## **Environment Agency**

### **Review of an Environmental Permit for an Installation subject to Chapter II of the Industrial Emissions Directive under the Environmental Permitting (England & Wales) Regulations 2010 (as amended)**

The Permit number is: EPR/BL1029IP  
The Operator is: Cemex UK Cement limited  
The Installation is: South Ferriby Cement Plant  
This Variation Notice number is: EPR/BL1029IP/007

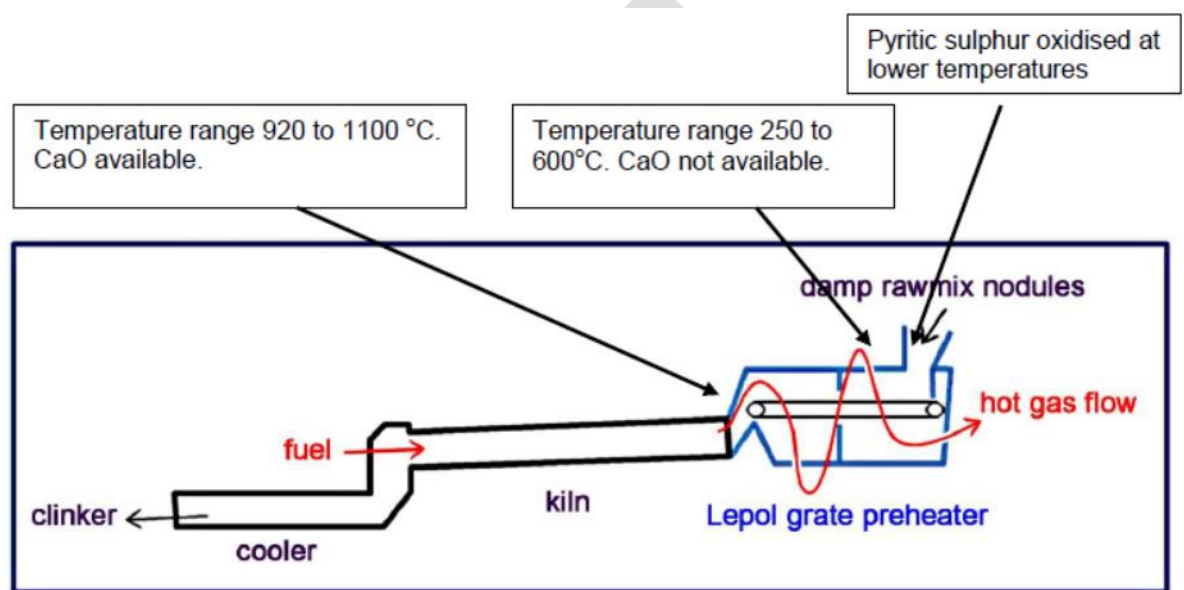
- Technical: “the configuration of the plant on a given site, making it more technically difficult and costly to comply”. The most common method of clinker production in the UK is the dry process/pre-heater with rotary kiln. This method will capture a high proportion of free sulphur in the sulphate form in clinker. The Lepol kilns used at South Ferriby have a more limited contact time so less free sulphur is absorbed into the clinker with consequently more released as SO<sub>2</sub>. The Kimmeridge clay available at South Ferriby is the primary source of the pyritic sulphur and is intimately mixed with the limestone raw material. This raw material, is heated up slowly on the Lepol grate in the temperature range of 250°C to 600°C. As the sulphur is not in sulphate form it is oxidised to SO<sub>2</sub> and there is only a limited opportunity for this SO<sub>2</sub> to react with the Calcium oxide (CaO) to form calcium sulphate (CaSO<sub>4</sub>) due to the formation of CaO at temperatures above 920°C. Scrubbing does occur further into the Lepol grate after the majority of the sulphur from the clay has been oxidised and released. This plant configuration meets the technical criteria for article 15(4).

The operator has a valid derogation request against the BAT conclusions 21. The derogation request is based on the technical characteristics of the plant, specifically the configuration of the Lepol kilns making it more technically difficult to comply with the BAT-AEL. The geographical location impacts and recent investment in techniques to abate or reduce Sulphur at source were also considered as suitable arguments to proceed with a derogation review. The operator has described 5 relevant options for achieving the BAT-AEL and justified the screening out 2 options; replacement of raw materials and site closure until a scrubber was fitted. 3 options were taken forward to conduct a cost benefit analysis including; fitting a wet scrubbing system, building a new cement plant and the operator preferred option of continuing the use of lime absorbent and managing fuel Sulphur content as a means of enabling a reduction in the ELV from 1000mg/Nm<sup>3</sup> to 600mg/Nm<sup>3</sup>. The derogation would continue until the next permit review in line with the BREF timetable.
